Committee of Experts on the Transport of Dangerous Goods and on the Globally Harmonized System of Classification and Labelling of Chemicals

Sub-Committee of Experts on the Transport of Dangerous Goods

Electric storage systems: sodium-ion batteries

Sodium ion batteries: Assignment of a dedicated UN number and related special provisions – corrections to document ST/SG/AC.10/C.3/2021/55

Figure 5.2.5

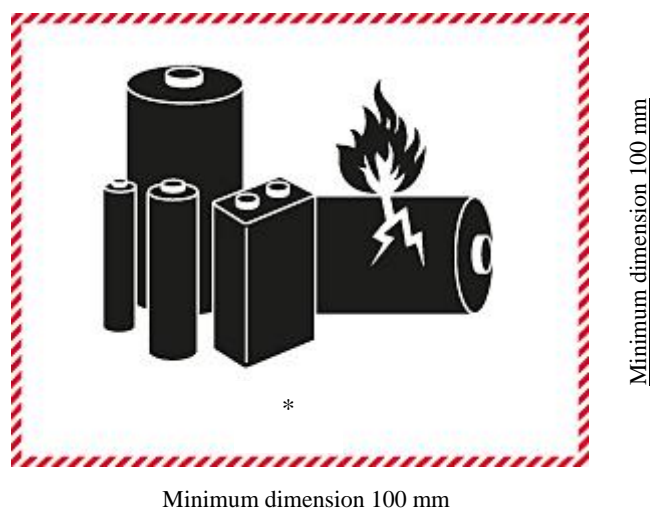
9 To allow appropriate hazard identification, the current “lithium battery mark” should be applicable to sodium ion batteries.

“5.2.1.9 Lithium or sodium ion battery mark

5.2.1.9.1 Packages containing lithium or sodium ion using organic electrolyte cells or batteries prepared in accordance with special provision 188 shall be marked as shown in Figure 5.2.5.

5.2.1.9.2 The mark shall indicate the UN number, preceded by the letters “UN”, i.e. “UN 3090” for lithium metal cells or batteries, ~~or “UN 3480” for lithium ion cells or batteries,~~ or “UN XXXX” for sodium ion using organic electrolyte cells or batteries. Where the ~~lithium~~ cells or batteries are contained in, or packed with, equipment, the UN number, preceded by the letters “UN”, i.e. “UN 3091”, ~~or “UN 3481”~~ or “UN XXXY” as appropriate shall be

Lithium or sodium ion using organic electrolyte battery mark

The mark shall be in the form of a rectangle or a square with hatched edging. The dimensions shall be a minimum of 100 mm wide × 100 mm high and the minimum width of the hatching shall be 5 mm. The symbol (group of batteries, one damaged and emitting flame, above the UN number(s) for ~~lithium ion or lithium metal batteries or cells~~) shall be black on white or suitable contrasting background. The hatching shall be red. If the size of the package so requires, the dimensions may be reduced to not less than 100 mm wide × 70 mm high. Where dimensions are not specified, all features shall be in approximate proportion to those shown.”
